RE: Turkey Point Units 3 and 4  
Docket Nos. 50-250 and 50-251  
RAI Response for Addition of  
Spent Fuel Pool Cask Area Rack Amendment

**RESPONSE TO**  
**REQUEST FOR ADDITIONAL INFORMATION**  
**ADDITION OF SPENT FUEL POOL CASK AREA RACK AMENDMENT**  
**TURKEY POINT PLANT, UNITS 3&4**  
**DOCKET NOS. 50-250 AND 50-251**

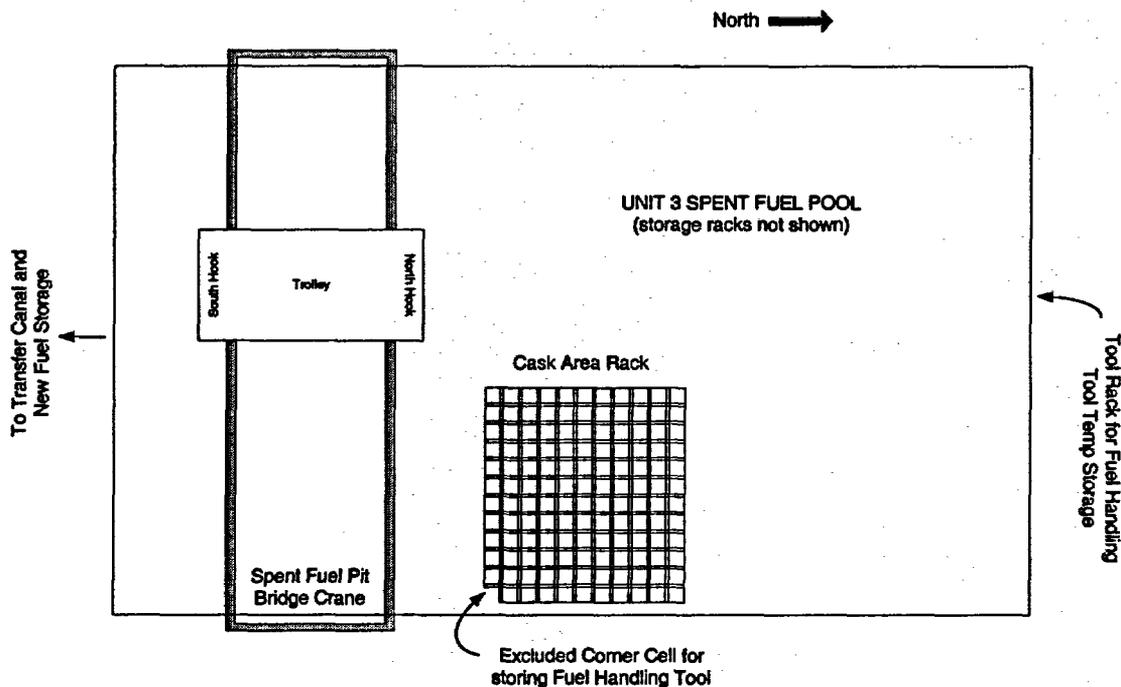
From a safety perspective, the improper orientation and subsequent misloading of the cask area rack during rack installation and fuel loading operations is unlikely and nearly impossible for the following reasons.

- The cask area rack design includes an excluded corner cell designated for the storage of the fuel handling tool, making the rack asymmetric. A portion of the corner cell's two outer faces has been removed to accommodate storage of the tool. This feature establishes a unique orientation for the cask area rack that is easily verified through visual observation prior to lowering the rack into the pool. Orienting the rack in any configuration without the vacant corner cell visible facing the pool wall would be apparent to the installation crew and a violation of the installation procedure.

- The cask area rack has a rectangular footprint. Because of the close tolerances between the cask area dimensions and the rack dimensions, the only possible misorientation of the rack is by 180 degrees (i.e., backwards). This would result in the excluded corner cell being installed in the center of the spent fuel pool as opposed to along the east wall. Again, this misorientation would be apparent to the installation crew and a violation of the installation procedure.

- The rack installation procedure will require a Quality Control holdpoint to verify proper rack orientation before immersion into the pool. This holdpoint provides an independent verification that the rack is properly oriented. The procedural controls during rack installation and the independent verification of proper rack orientation
